PAVILION SHORE PARK-REST ROOMS/SHELTER AREA JSP16-02

Consideration at the request of City of Novi for approval of Preliminary Site Plan, a Section 9 Façade waiver and Storm Water Management Plan for Pavilion Shore Park – Rest Rooms/Shelter Area, JSP 16-02. The subject property is located in Section 3 north of Thirteen Mile Road and east of South Lake Drive. The applicant is proposing to construct approximately 1,872 square feet building that will function as rest area and picnic shelter area for Pavilion Shore Park.

PLANNING REVIEW

ENGINEERING REVIEW

SITE LAYOUT AND GRADING PLAN

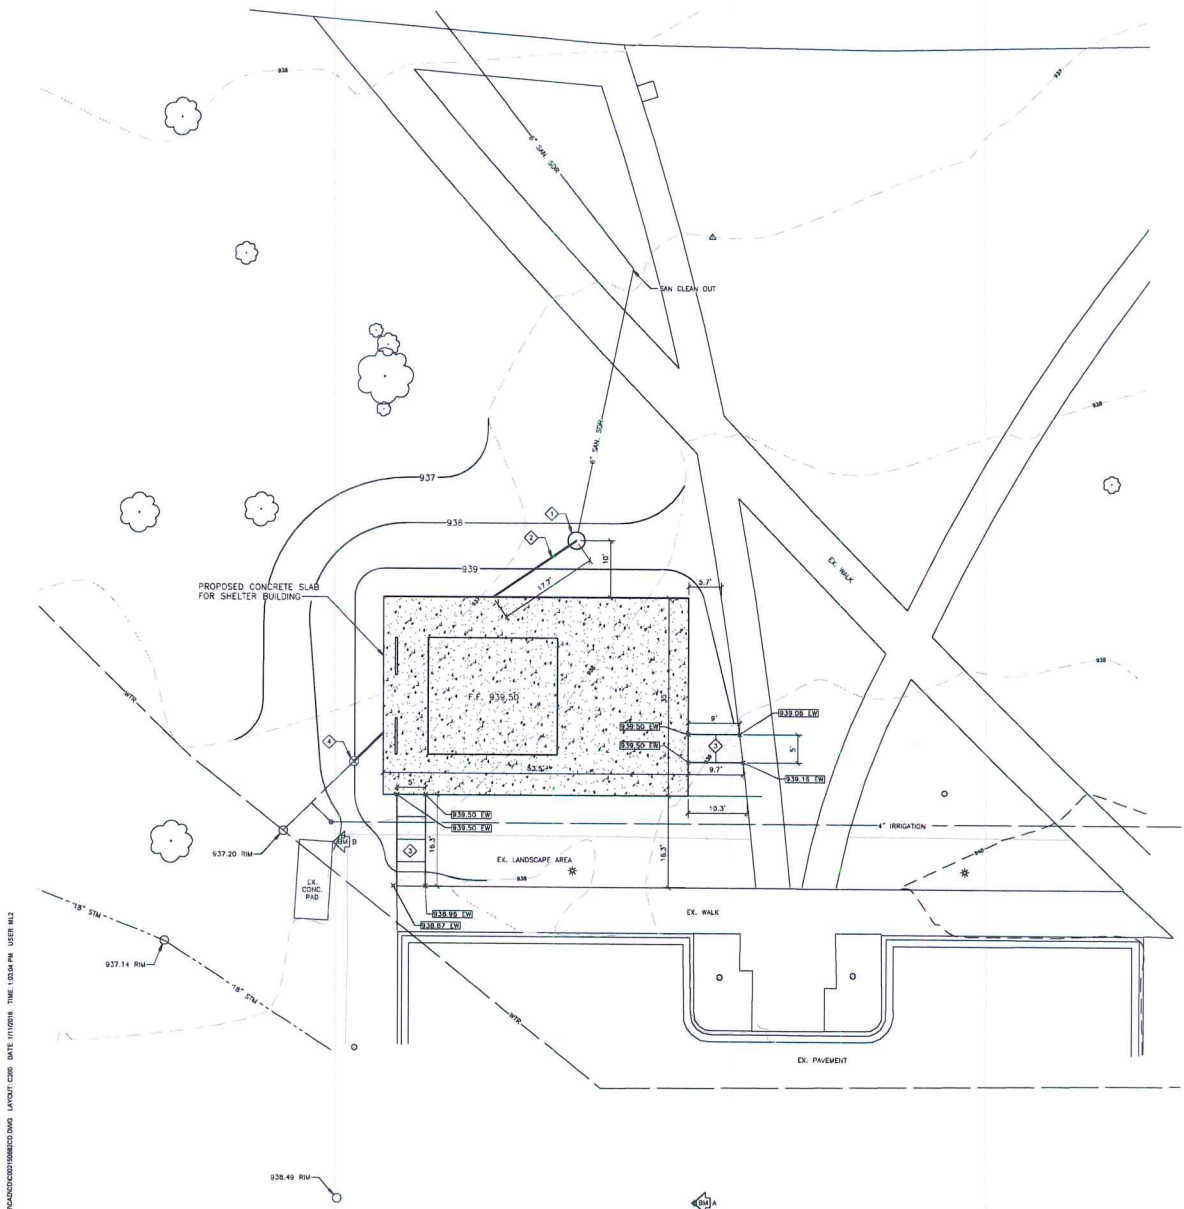
1. Provide a note on the plans that all work shall conform to the current City of Novi standards and specifications.
2. Provide a minimum of two ties to established section or quarter section corners.

3. Revise the plan set to reference at least one city established benchmark. An interactive map of the City's established survey benchmarks can be found under the 'Map Gallery' tab on www.cityofnovi.org.

5. Provide a construction materials table on the Utility Plan listing the quantity and material type for each utility (water, sanitary and storm) being proposed.

8. Provide the size of the existing water main being tapped.

9. Provide the size of the proposed manhole.
10. Provide inverts and slope of sanitary sewer lead.
11. Revise sanitary lead to be 6-inches in diameter.

12. Show any roof lead location, size, and material.

13. The Storm Water Management Plan for this development shall be designed in accordance with the Storm Water Ordinance and Chapter 5 of the new Engineering Design Manual.
 - a. Clarify why only half the roof area is being considered in the bioretention calculations.

14. Show locations of proposed bioretention.
15. Provide a cross-section of proposed bio retention.
16. The detail for the bioswale shall indicate the above-grade ponding depth, and shall show the overflow catch basin. Include the design sideslopes, currently shown vertical.
17. A secondary overflow catch basin shall be provided outside of limits of the bioswale.
18. The planting soil media shall consist of a mixture such as 50% topsoil/50% sand or 20% topsoil/60% sand/20% compost, or similar.
19. Provide a cross-section for the bioswale, including all relevant elevations, inverts and dimensions.

20. Provide a cross-section for the proposed paving.
21. Provide proposed grades for concrete walk.
22. Add a note to the plan stating that the emergency access gate is to be installed and closed prior to the issuance of the first TCO in the subdivision.

PROJECT: PAVILION SHORE PARK RESTROOM BUILDING
 SHEET: Landscape Plan

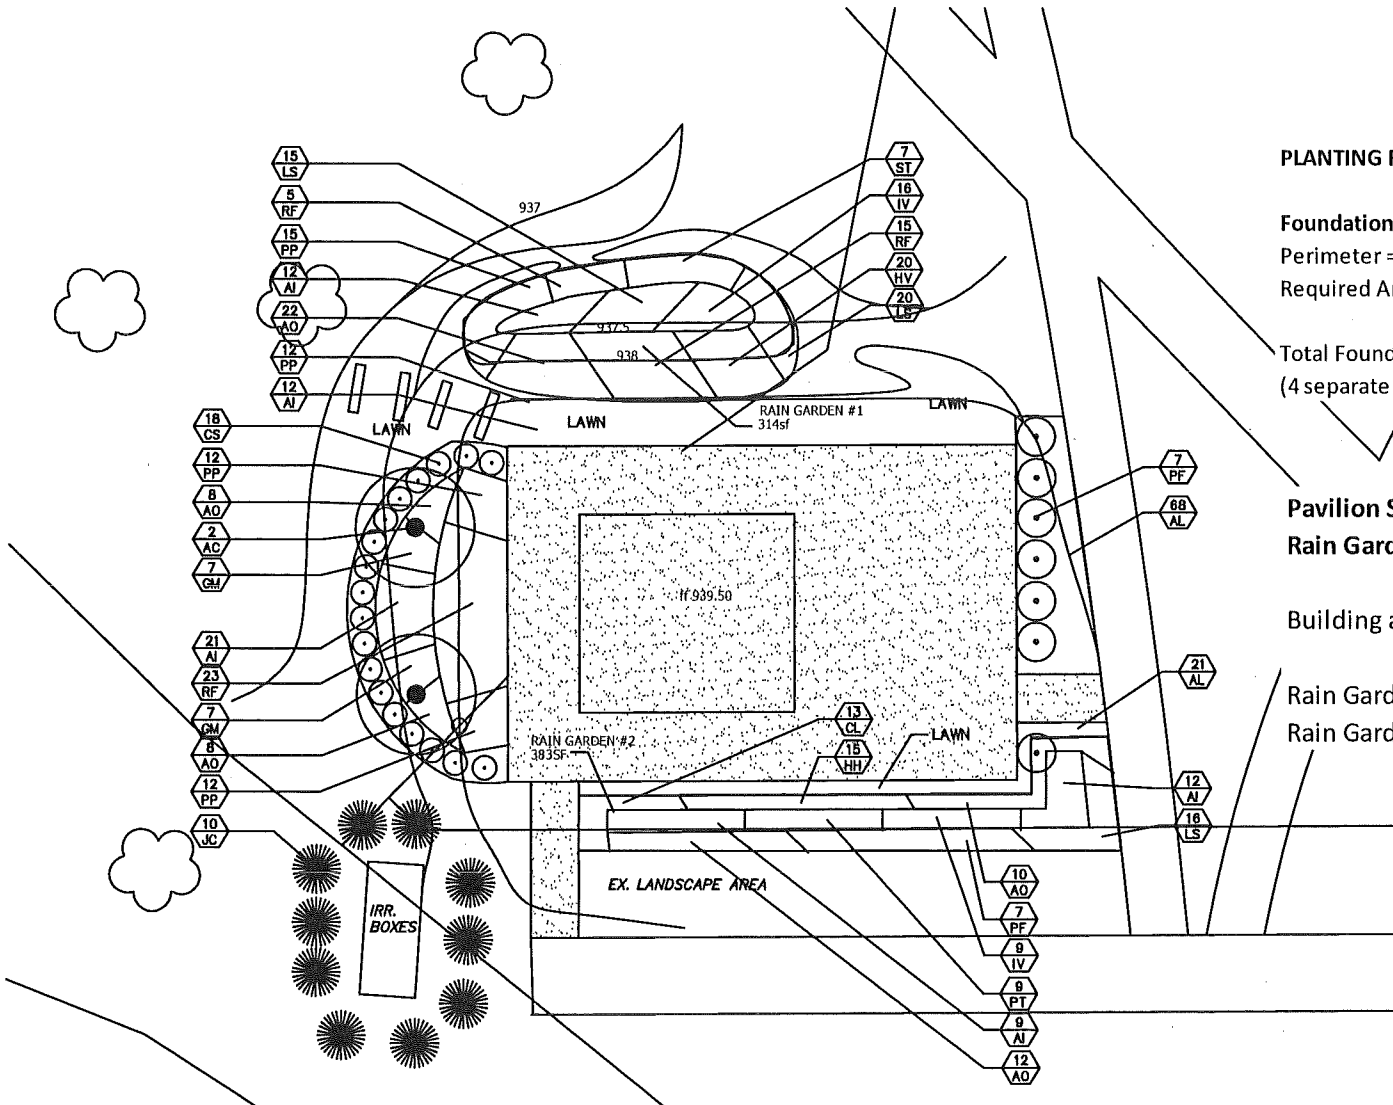
1. Existing trees near site need to be identified with size and identification.
2. Tree fencing is shown around trees near site, and detail is correct.

The building is behind the existing parking lot. Based on the building frontage of 53.5 feet, 2 canopy trees and 3 subcanopy trees are required. 2 subcanopy trees are provided on the west side of the building as there is no room between the building and the parking lot due to the rain garden. No canopy trees are proposed but there are a number of existing trees to remain west of the building.

1. Based on the frontage, 2 street trees are required. There is one existing street tree near the building. No street trees are possible in the front parking lot island due to underground storm sewer.
2. **An additional street tree west of the parking lot should be provided.**

1. Foundation landscaping needs to be provided. Per the plan, this will be $177\text{ft} \times 8 = 1416$ sf.
2. Foundation landscaping provided exceeds the requirement.

1. Two rain gardens are proposed to handle the runoff from the roof, one on each side of the building.
2. **Please clean up and label the contours and verify that the proposed rain gardens provide the required volume and expand if necessary.**
3. **Please verify that the rain garden designs meet city requirements for overflow conditions.**

1. Two irrigation utility boxes near the proposed building do not meet the city requirements for screening.
2. Junipers have been proposed as screening around the boxes.

Costs for all plantings are provided, but costs for sod, seed and mulch need to be included with the other costs.

Figure 1: Perspective of proposed pavilion

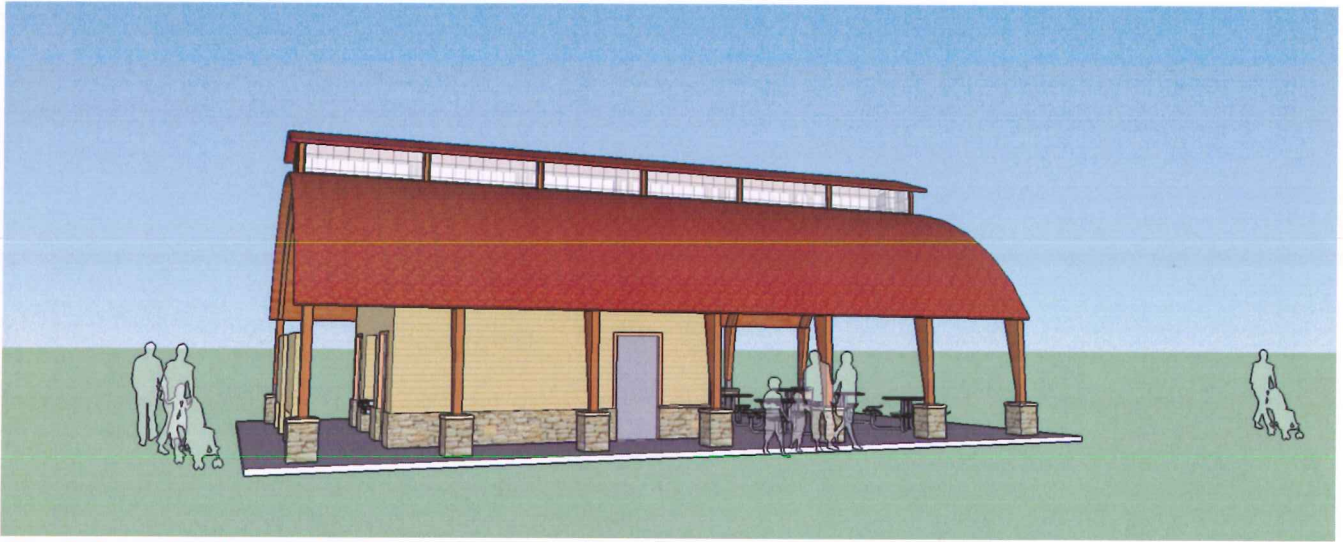
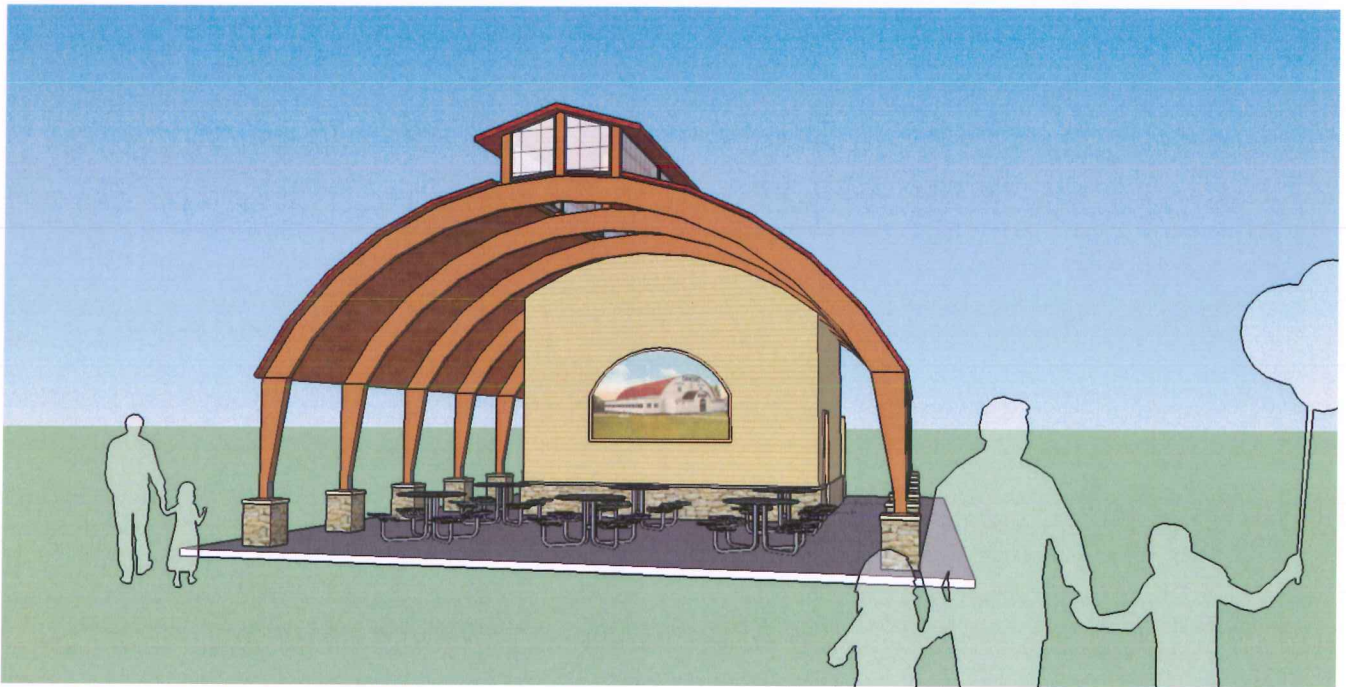
Façade Region 1	East	West	North	South	Façade Ordinance Section 2520 Maximum (Minimum)
Brick	0%	0%	0%	0%	100% (30% MIN.)
Stone Veneer	14%	15%	9%	9%	50%
Cementitious Siding	66%	62%	0%	0%	50% (Footnote 11)
Wood Trim, Painted	18%	21%	4%	4%	15%
Asphalt Shingles	0%	0%	86%	86%	25%
Limestone Coping	2%	2%	1%	1%	50%

As shown above the minimum percentage of brick is not provided on all facades, the percentage of Asphalt Shingles exceeds the maximum amount allowed by the Ordinance on the north and south facades, and the percentages of Cementitious Siding and Wood Trim exceed the maximum amount allowed by the Ordinance on the east and west facades. The Architect has stated that the design objective was to be reminiscent of the Walled Lake Casino that once stood on the same site. We believe this has been accomplished in exemplary fashion. It is our recommendation that the deviations from the Façade Ordinance are justified on the basis of historical context and that a Section 9 Waiver be granted for the underage of Brick on all facades, the overage of Asphalt Shingles on the north and south facades, and the overage of Cementitious Siding and Wood Trim on the east and west facades.

- a. To allow the underage of brick on all sides (30 percent minimum required, 0% proposed), overage of cementitious siding on east and west facades (50% maximum allowed, 66 and 62 percent proposed respectively), overage of Wood Trim on east and west facades (15 percent maximum allowed, 18 and 21 percent proposed respectively) and overage of Asphalt Shingles on north and south facades (25 percent maximum allowed, 86 percent proposed respectively) because the deviations are justified on the basis of historical context and the design is consistent with the intent and purpose of the Façade Ordinance, which is hereby granted.
